ATA6625 Errata and Data Sheet Clarifications

The functionality of the automotive qualified ATA6625 devices you have received is described in the Device Data Sheet 9376B–AUTO–08/16 except for the anomalies described in this document.

There are no silicon errata issues for the ATA6625.
This document contains just some detailed information in addition to the ATA6625 Data Sheet 9376B–AUTO–08/16.
There is no change in the product itself.

8-Lead Plastic Small Outline (SN) - Narrow, 3.90 mm (.150 In.) Body [SOIC]

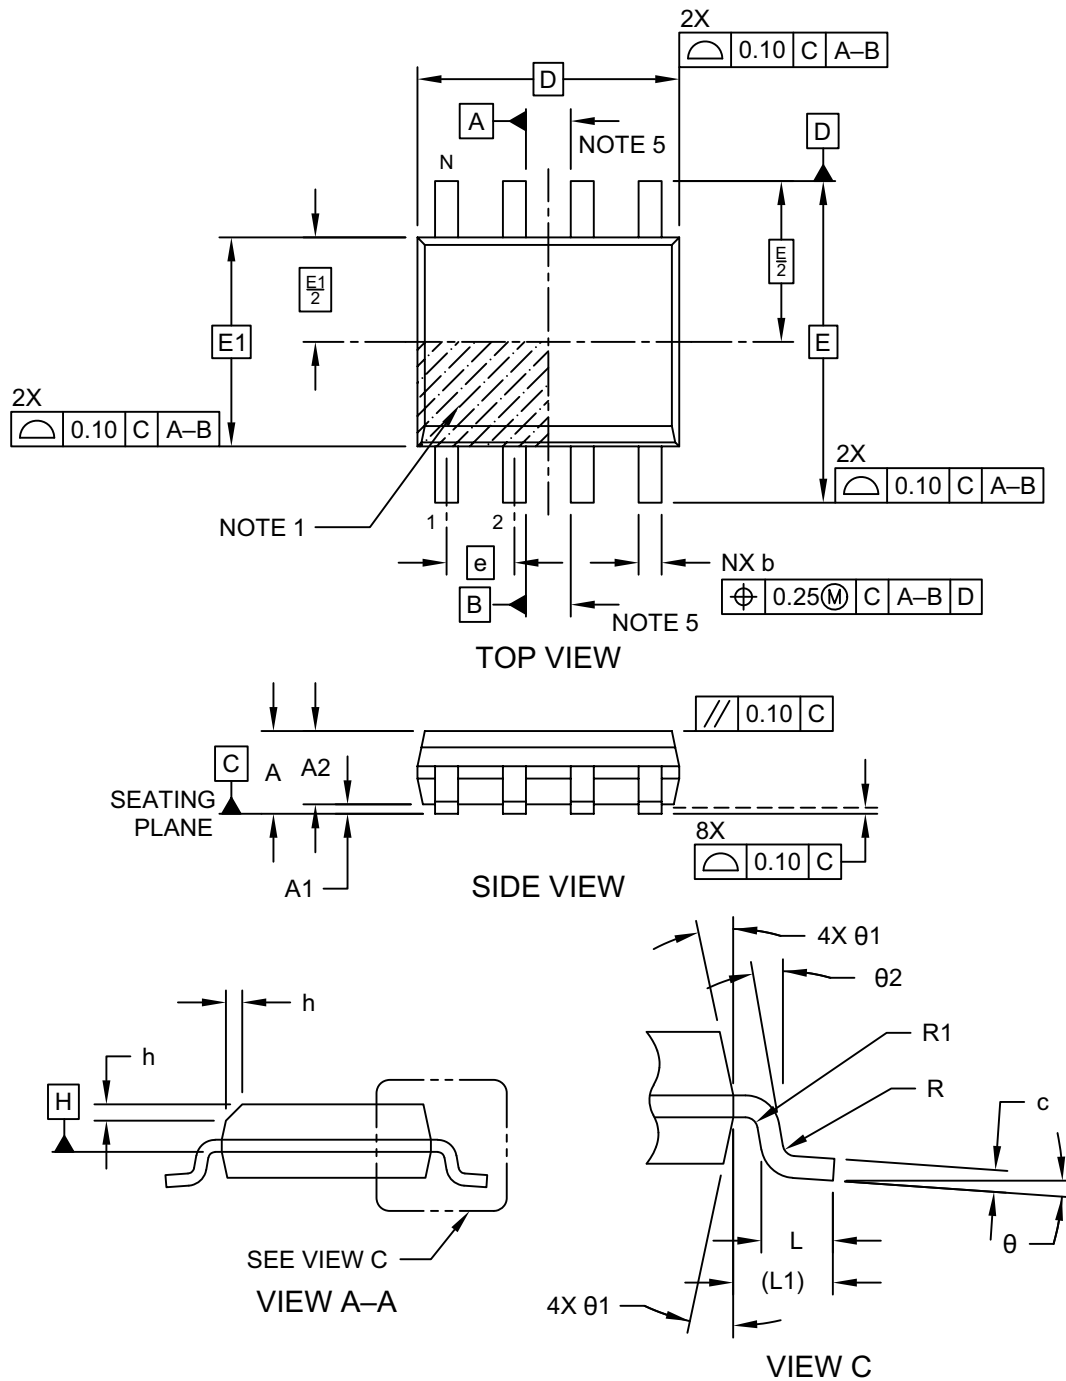
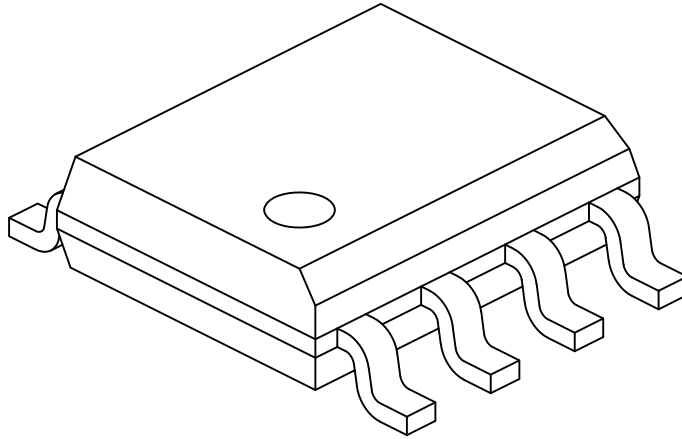
The package drawings have been updated. They have been converted from the former Atmel style to the Microchip Format.

For the 8-lead SOIC package, the dimensions are identical, there are no changes in any dimensions.

8-Lead Very Thin Plastic Dual Flat, No Lead Package (Q8B) - 3x3x1 mm Body [VDFN] With 2.40x1.60 mm Exposed Pad and Stepped Wettable Flanks; Atmel Legacy YCL

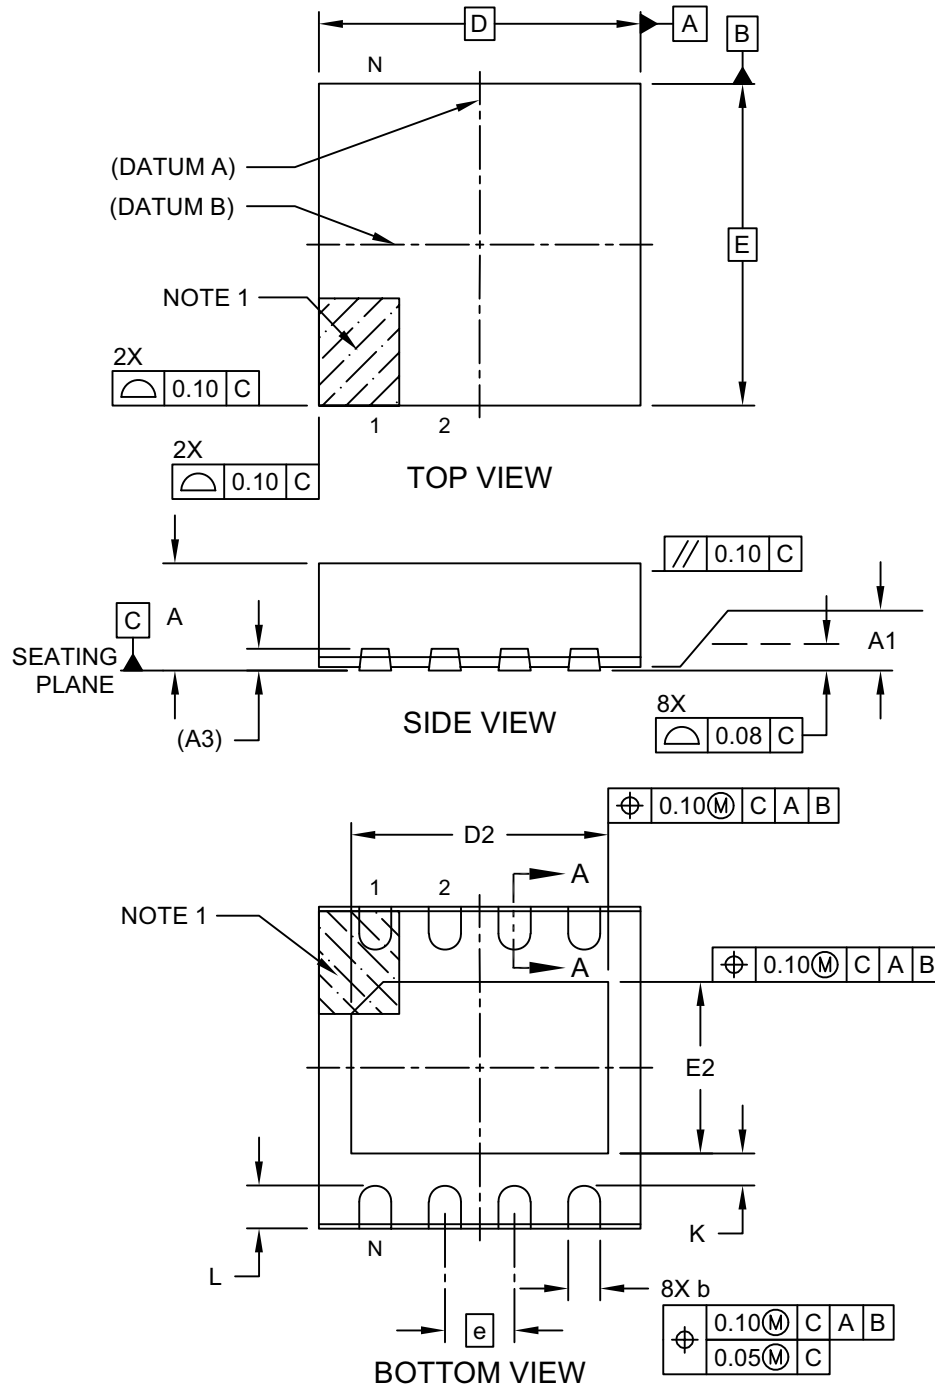
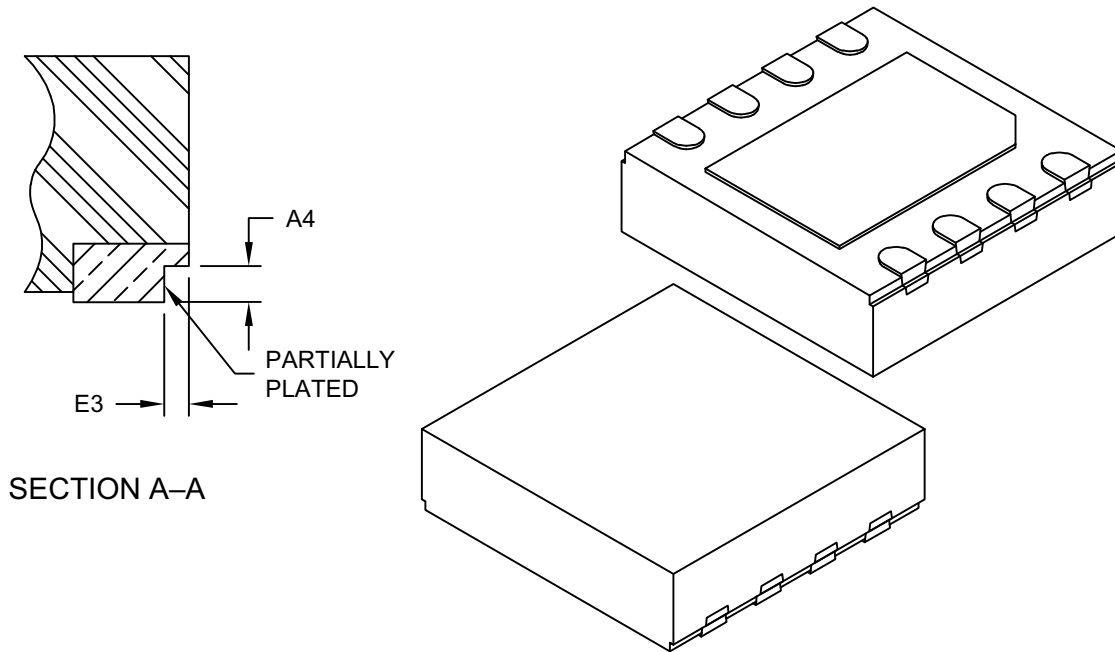
For the ATA6625 in the 8-lead VDFN package, the only dimensions which are different are listed in the following table:

**TABLE 2-1: LIST OF UPDATED DIMENSIONS
(ONLY FOR THE 8-LEAD VDFN PACKAGE)**

OLD			NEW			
Dimension	Symbol	Min.	Nom.	Max.	Min.	Nom.	Max.	Units
Overall Height	A	0.80	0.85	0.90	0.80	0.90	1.00	mm
Wettable Flank Step Length	D3	—	—	0.040	—	—	0.085	mm
Wettable Flank Step Heights	A4	0.10	—	0.15	0.10	—	0.19	mm

Units		MILLIMETERS		
Dimension Limits		MIN	NOM	MAX
Number of Terminals	N	8		
Pitch	e	0.65 BSC		
Overall Height	A	0.80	0.90	1.00
Standoff	A1	0.00	0.035	0.05
Terminal Thickness	A3	0.203 REF		
Overall Length	D	3.00 BSC		
Exposed Pad Length	D2	2.30	2.40	2.50
Overall Width	E	3.00 BSC		
Exposed Pad Width	E2	1.50	1.60	1.70
Terminal Width	b	0.25	0.30	0.35
Terminal Length	L	0.35	0.40	0.45
Terminal-to-Exposed-Pad	K	0.20	-	-
Wettable Flank Step Cut Depth	A4	0.10	-	0.19
Wettable Flank Step Cut Width	E3	-	-	0.085
